Access Compliance Report Public Rights-of-Way (Curb Ramps)

Main Street: N/A Cross Street: FOWLER_AVE Location: NW

ADA ID: RPAT220301111032 Ramp Type: Type 1 - Perpendicular Initial Pass/Fail: Fail Overall Compliance: No Severity Score: 2

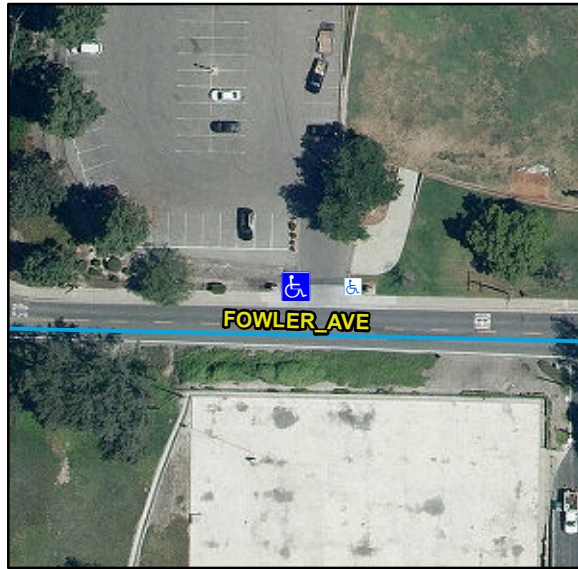
Compliance	Description	Data	Compliance	Description	Data
N/A	Ramp Length (in)	49	N/A	Flare Type LT	
Yes	Ramp Width (in)	54			N/A
Yes	Ramp Run Slope (%)	8.2	N/A	Flare Slope LT (%)	N/A
No	Ramp Cross Slope (%)	3.5	N/A	Flare Traversable LT	N/A
N/A	Landing Present	N/A	N/A	Flare Type RT	
N/A	Landing Length (in)	N/A			N/A
N/A	Landing Width (in)	N/A	N/A	Flare Slope RT (%)	N/A
N/A	Landing Run Slope (%)	N/A	N/A	Flare Traversable RT	N/A
N/A	Landing Cross Slope (%)	N/A	N/A	DWS Provided	N/A
N/A	Landing Movement Obstructed?	N/A	N/A	DWS Contrast	N/A
	Landing Movement Type	N/A	N/A	DWS Length (in)	N/A
N/A	Landing Shared	N/A	N/A	DWS Full Width	N/A
N/A	Clear Space	N/A	N/A	DWS Offset Left (in)	N/A
N/A	Clear Space To Crosswalk (in)	N/A	N/A	DWS Offset Right (in)	N/A
N/A	Marked Crosswalk 1	No	N/A	Marked Crosswalk 2	N/A
	Crossing 1 Direction	E		Crossing 2 Direction	N/A
	Marked Crosswalk 1 Width (in)	N/A		Marked Crosswalk 2 Width (in)	N/A

Possible Solutions:

Remove & Replace Entire Ramp.

R304.5.3, STD 1115
